SUBJECT: PLANNING COMMISSION SUMMARY – PRELIMINARY PLAT OF STIENESSEN ADDITION

TO: PLANNING COMMISSION
FROM: KEN ONDICH, PLANNING / COMMUNITY DEVELOPMENT DIRECTOR
SUBJECT: REQUEST FOR PRELIMINARY PLAT REVIEW OF STIENESSEN ADDITION CONSISTING OF 3 LOTS ON 4.1 ACRES IN THE LE SUEUR COUNTY R1, URBAN/RURAL RESIDENTIAL ZONING DISTRICT, AS PROPOSED BY BEN STIENESSEN, APPLICANT.
DATE: 6/12/24

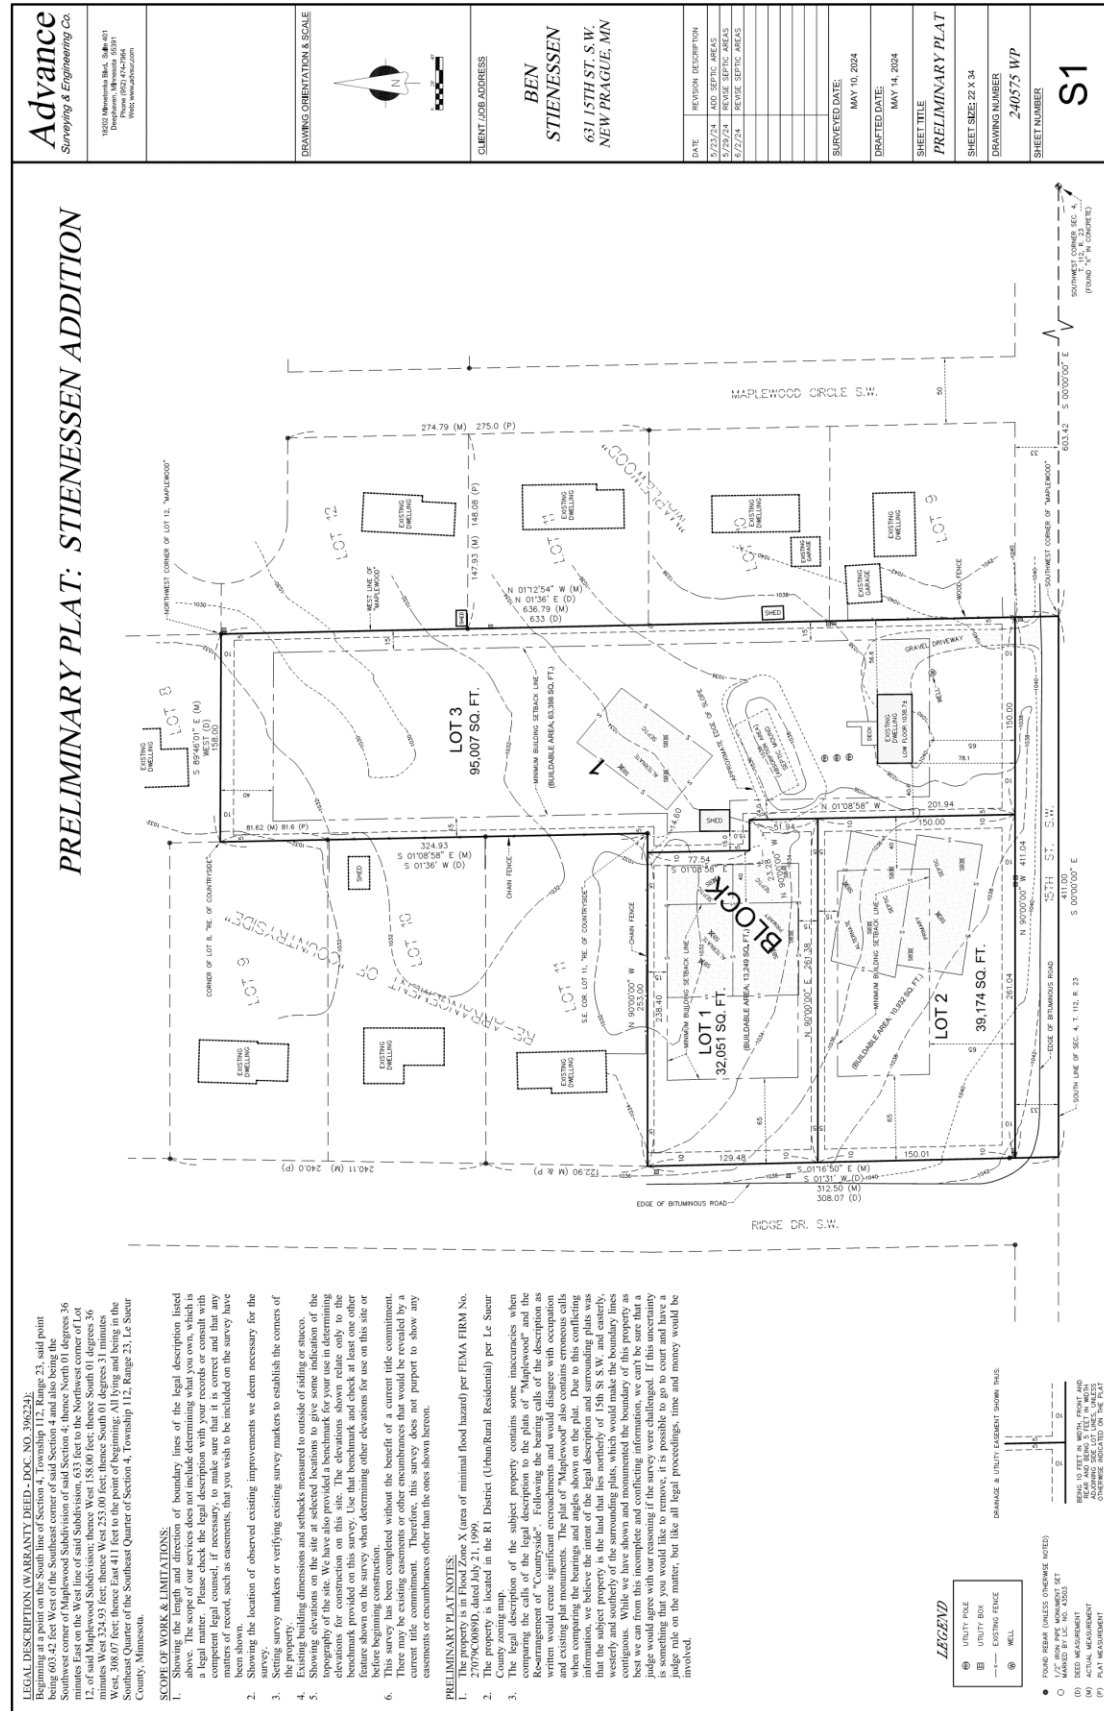
Two of the three proposed lots (Lots 1 and 2) do not meet the minimum lot requirements. Le Sueur County is reviewing variance requests for these lots at their June 20th meeting. Lot 1 requires a variance for lot width (129.48'), depth (238.40') and area (32,051 sq. ft.) while Lot 2 requires a variance for lot area (39,174 sq. ft.) only.

Access to the existing home will remain from 15th Street SW while the two new lots will be accessed from Ridge Drive SW. New driveway access will not be allowed from 15th Street SW as it is identified as a future major collector.

1. Approval is granted in general accordance with the Preliminary Plat submittal dated 6/2/2024 on file with the New Prague Planning Department.
2. The Preliminary Plat is issued for a permit of twelve (12) months and shall become null and void without further action from the Planning Commission or City Council unless the final plat is filed within twelve (12) months of the City Council granting Preliminary Plat approval.

3. Preliminary Approval is subject to all requirements of the City Attorney including review and approval of the Title Commitment.
4. Approval is subject to all requirements of LeSueur County Planning and Zoning and Environmental Services Departments, including approval of lot size variances for proposed Lots 1 & 2.

5. A Wetlands Conservation Act “Certificate of No Loss or Exemption” must be filed prior to the final plat approval.
6. City Park Land Dedication (including a future trail segment along 15th Street SW), Saw and Seal Fee, Sidewalk Fee and Emergency Warning Siren Fee and city utility area charges and connection fees are being delayed until the time at which the property is annexed to the City and at the rates applicable at that time.

7. No new driveway access to 15th Street SW will be permitted as it is a future major collector road.
